APPEAL SUMMARY

Appeal ID: 23789	Project Address: 3800 SE 164th Ave
Hearing Date: 6/10/20	Appellant Name: Hayley Purdy
Case No.: B-002	Appellant Phone: 503-896-5341
Appeal Type: Building	Plans Examiner/Inspector: Alice Johnson, Thomas Ng
Project Type: commercial	Stories: 3 Occupancy: R-2 Construction Type: V-B
Building/Business Name: Centennial Place Apartments	Fire Sprinklers: Yes - Throughout
Appeal Involves: Erection of a new structure	LUR or Permit Application No.: EA #19-201053
Plan Submitted Option: pdf [File 1] [File 2] [File 3] [File 4] [File 5]	Proposed use: Multi-family

CENTENNIAL PLACE APARTMENTS

1 STAIR 1 - FIRST FLOOR PLAN
3/8" = 1'-0"

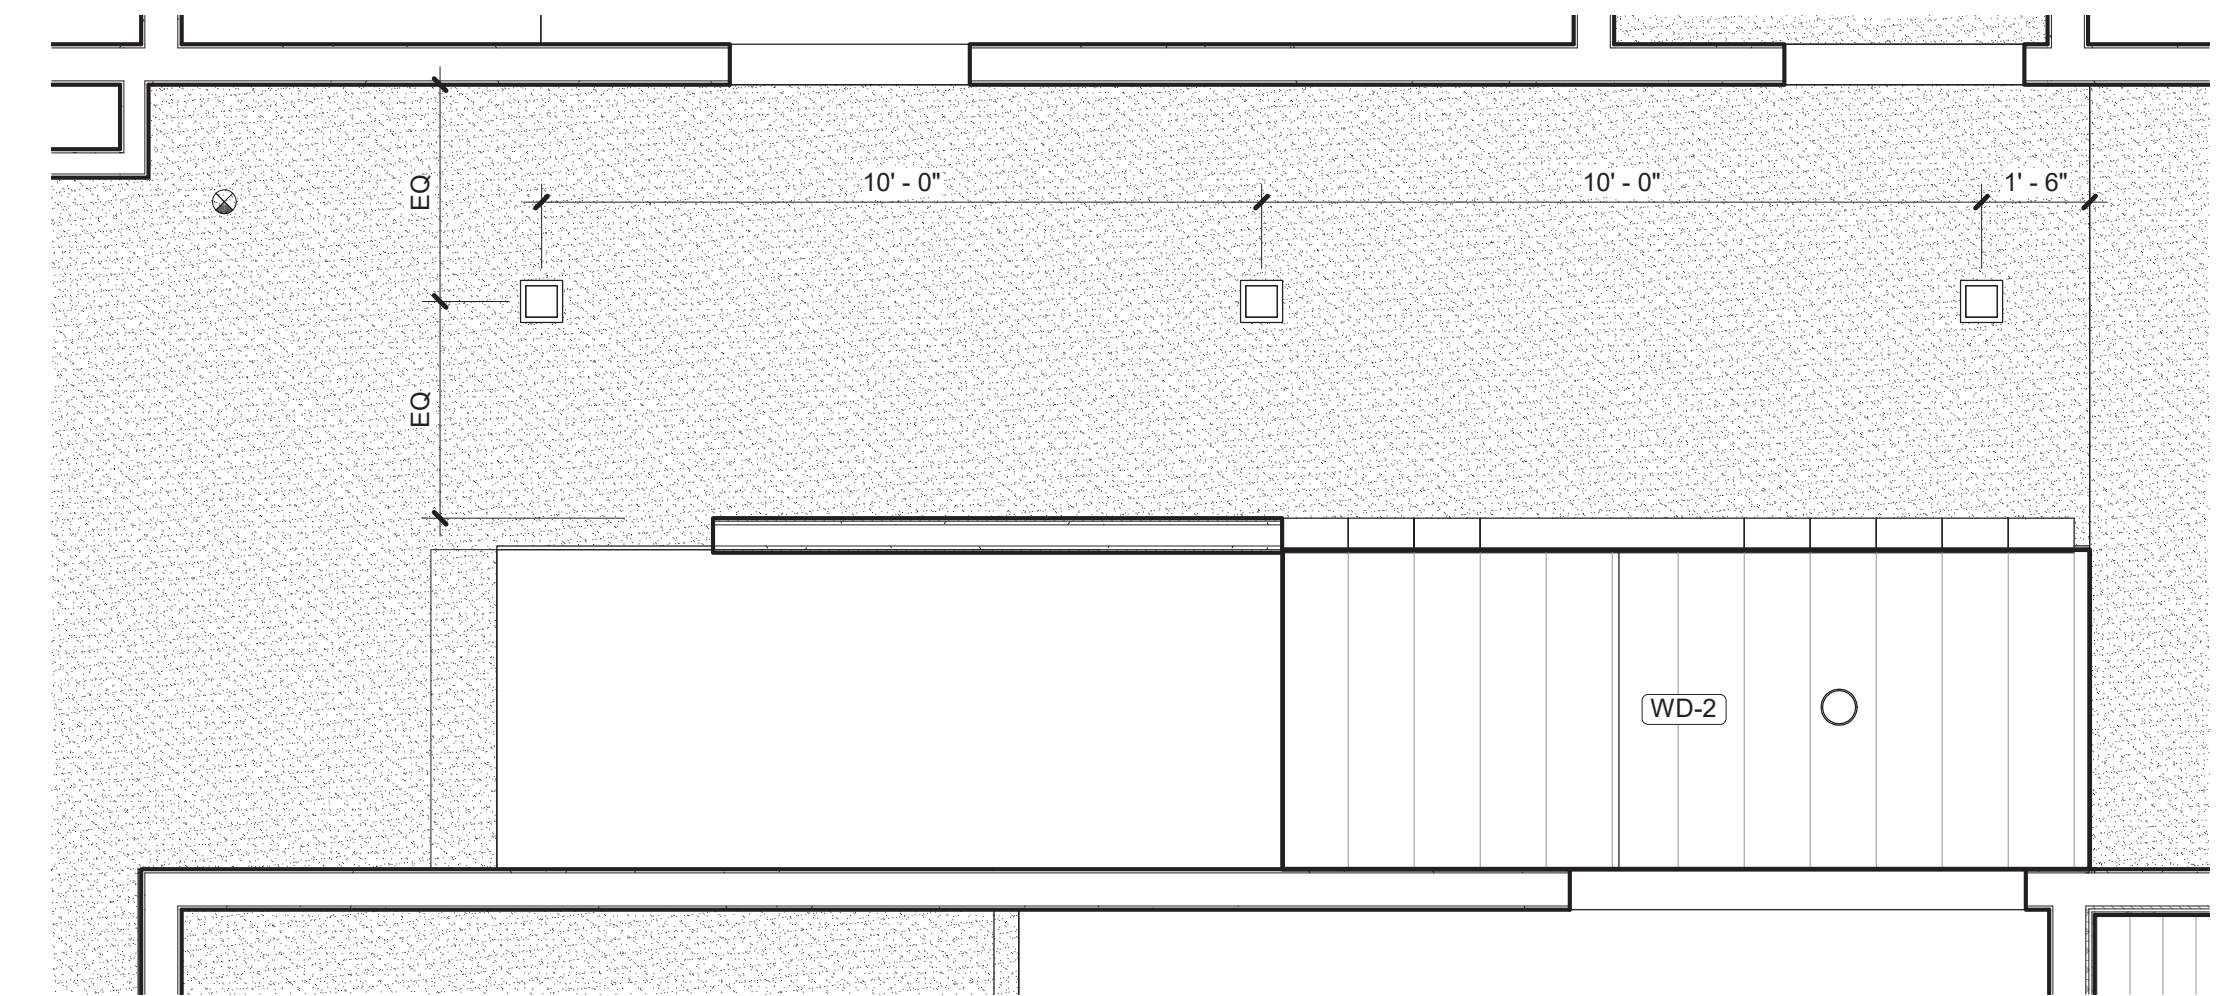
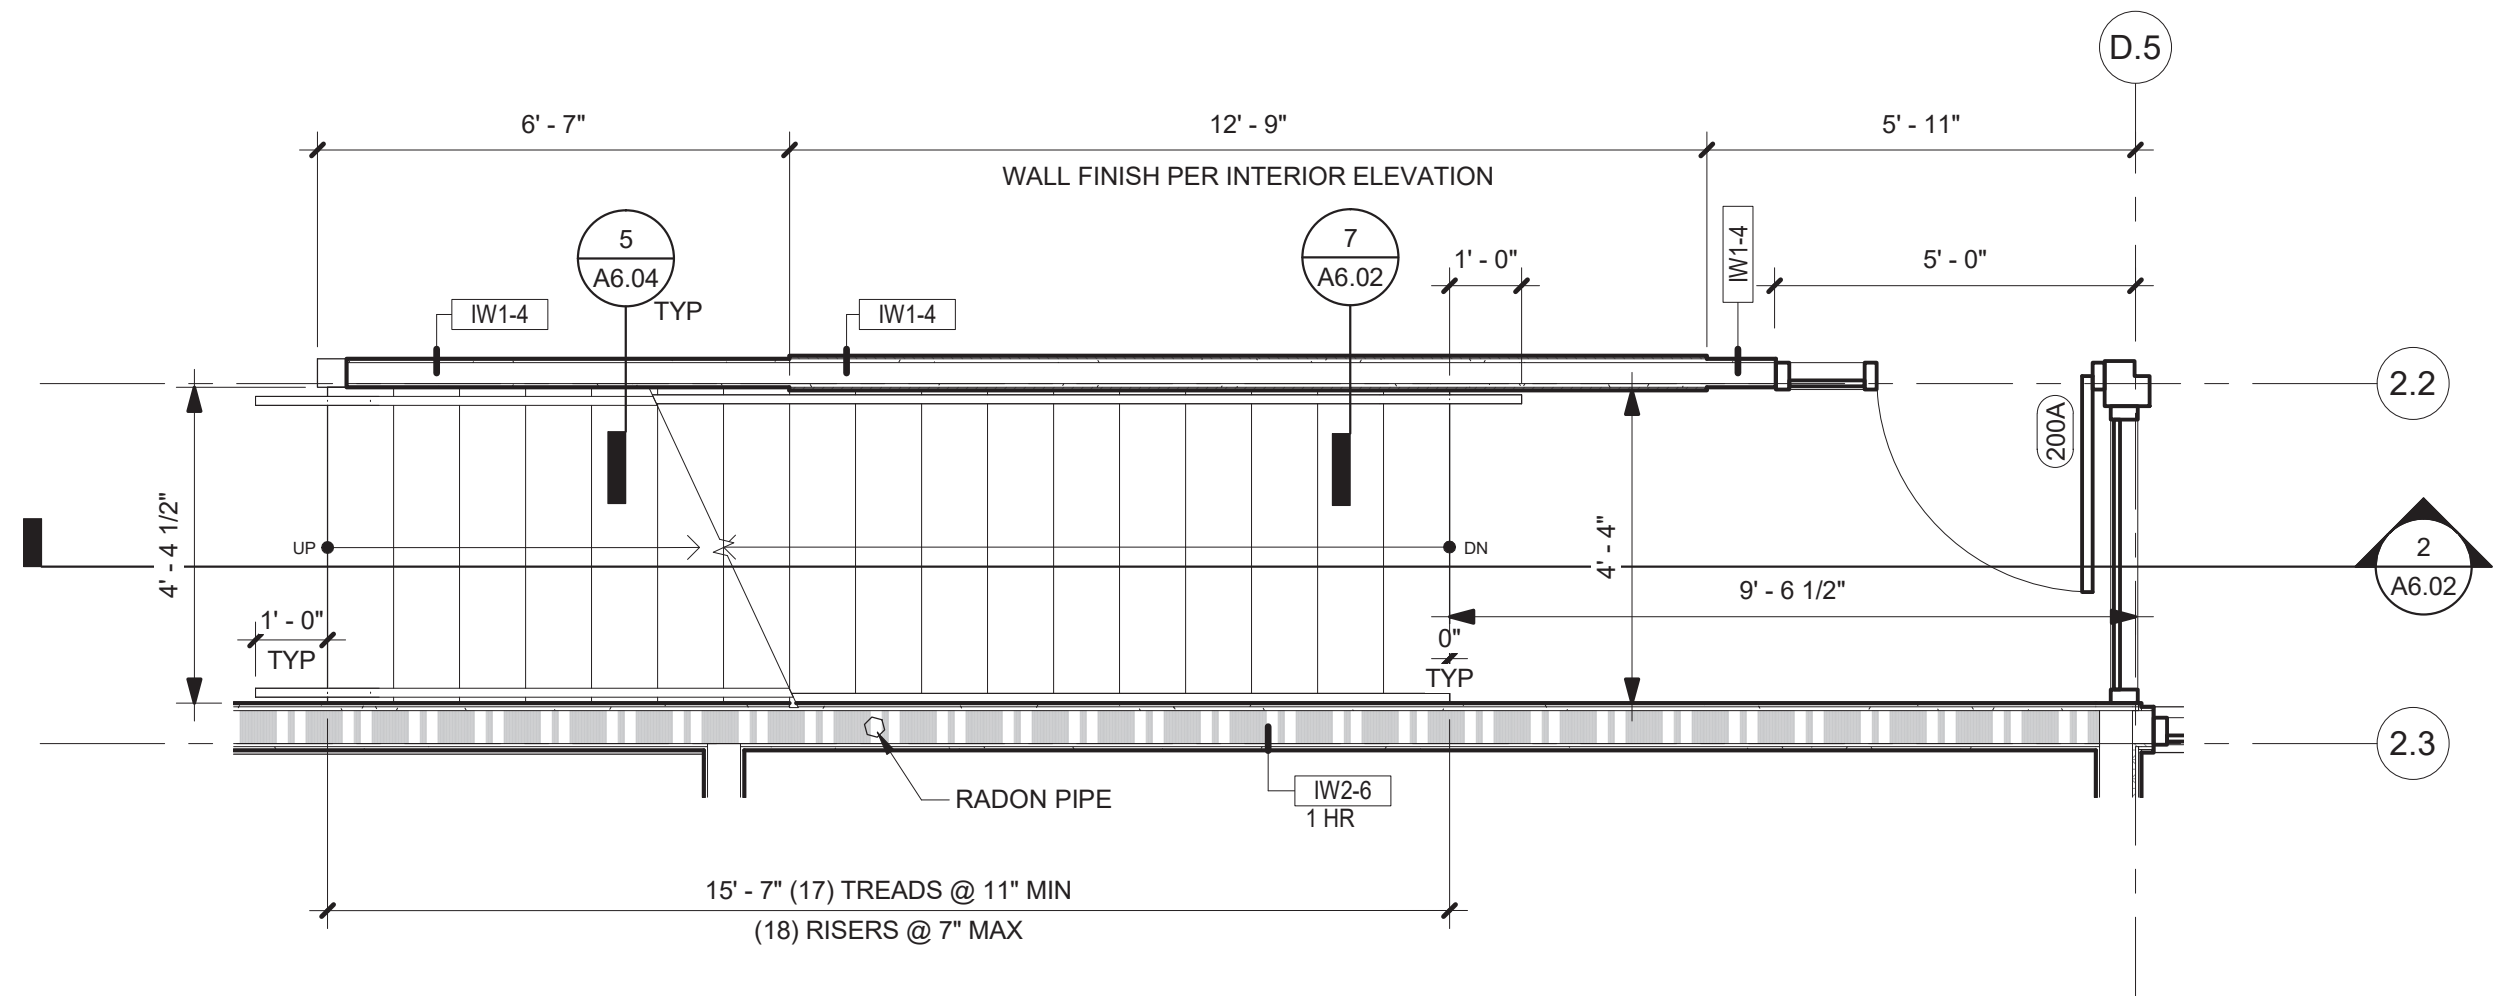
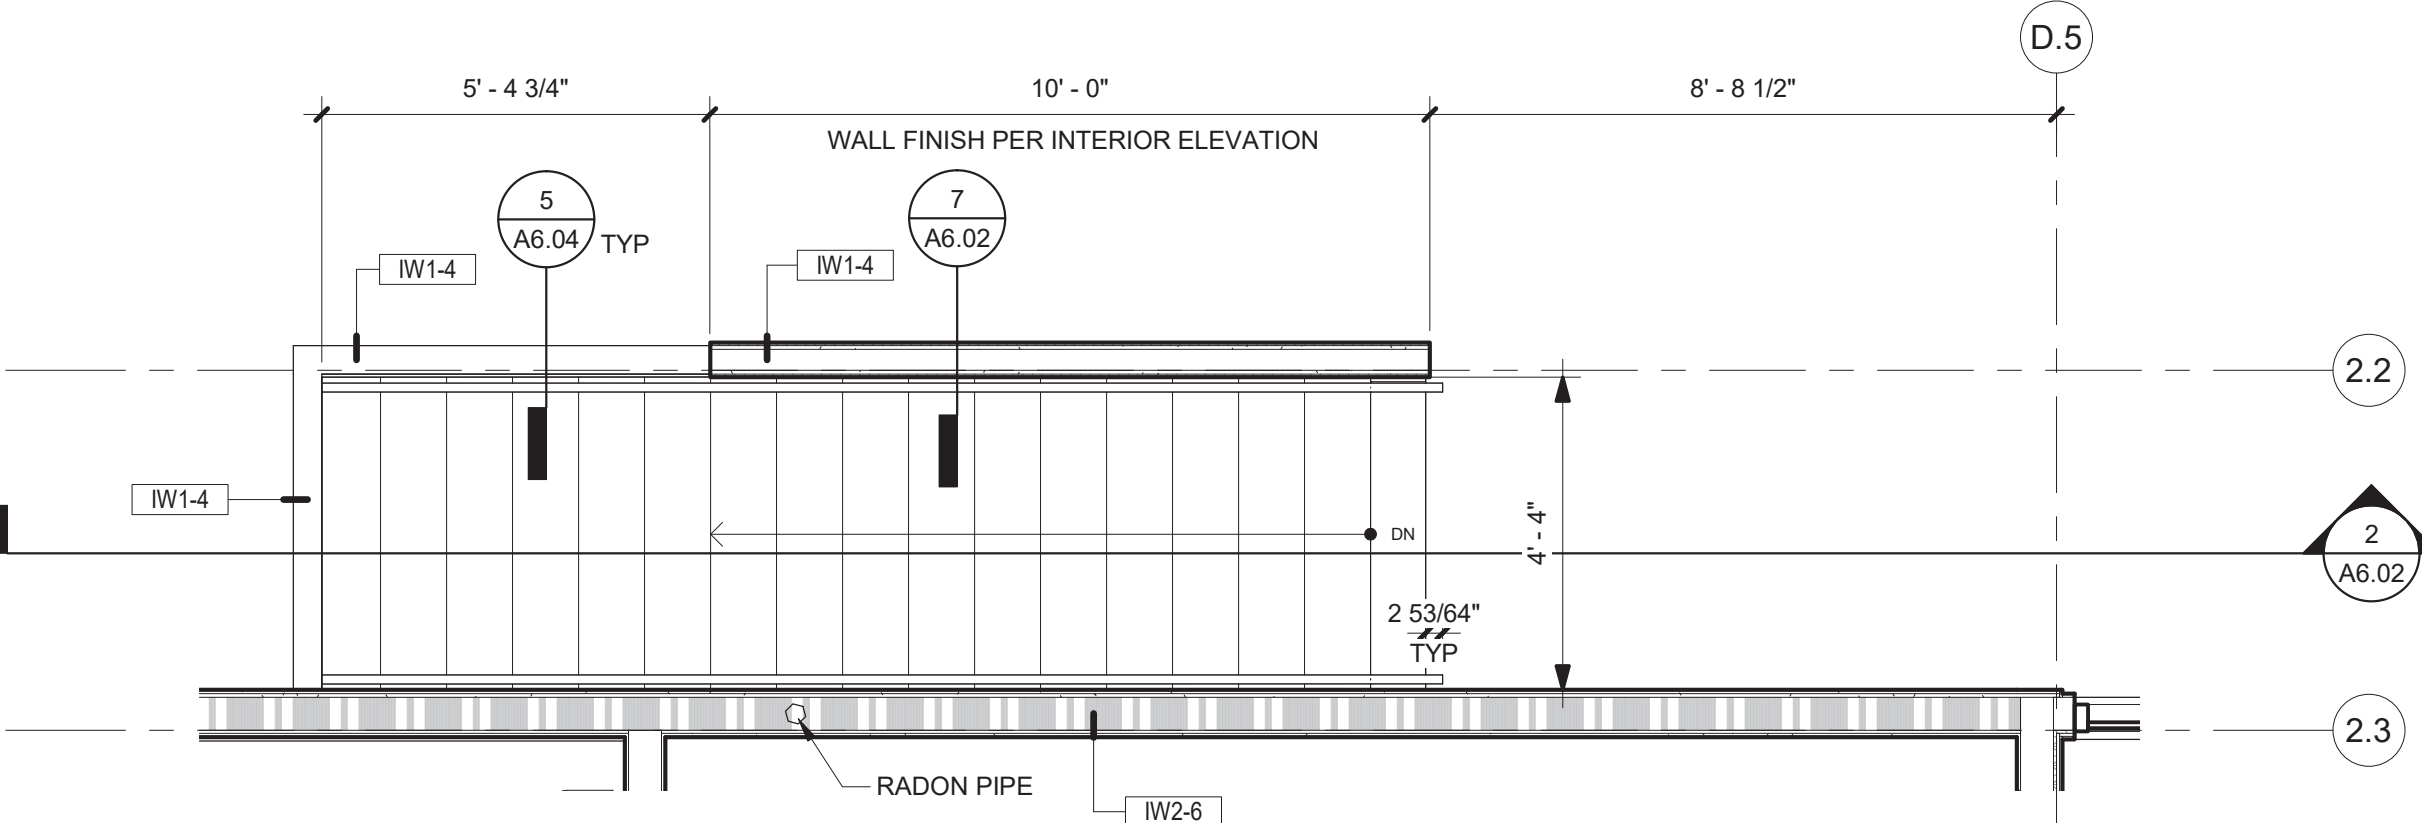
Code Modification or Alternate Requested Allow for a 2 story vertical opening containing an exit access stairway in accordance with section 1019 at Stair S1.

Proposed Design Our interpretation of the code, similar to the IBC commentary, references sections 712.1.12 and 1019.3 of the OSSC 2019. These sections of the code allow us to provide the two-story opening, between the first and second floor at Stair S1.

Stair S1 is not a path of egress in the building's exiting strategy. Two additional staircases are provided, Stair S2 and S3, with adequate exit access travel distance. Therefore, Stair S1 qualifies as an Exit Access Stairway which is section 712.1.12. If BDS agrees with the IBC Code commentary, then 712.1.9 would not supersede 712.1.12 and a three story opening is allowed.

- An open stair in the main lobby that encourages tenants to use the stairs instead of using the elevator. The stair is part of owner's goals for providing tenants with healthy-living opportunities. The health, accessibility, life safety and fire protection requirements are met as required with these conditions:
- Exiting provides life safety measures more than what is required by code.
- In the event of a fire, or presence of smoke, the monitored smoke detection system will immediately send an activation signal to the central monitoring system, notify the fire department and alert building occupants.
- Stair S2 and S3 are provided and more than adequately meet exit access travel distances. Stair S1 is not necessary for exiting requirements.
- Stair S1 is enclosed at the top of the second floor landing, and will be protected from the corridor by a unrated wall and accessible door.

4. Open exit access stair in main lobby: Granted provided sprinklers and draft curtains per OSSC 1019.3, condition 4 are installed at the 2nd floor ceiling level and the door is 20 minute rated with a closer.
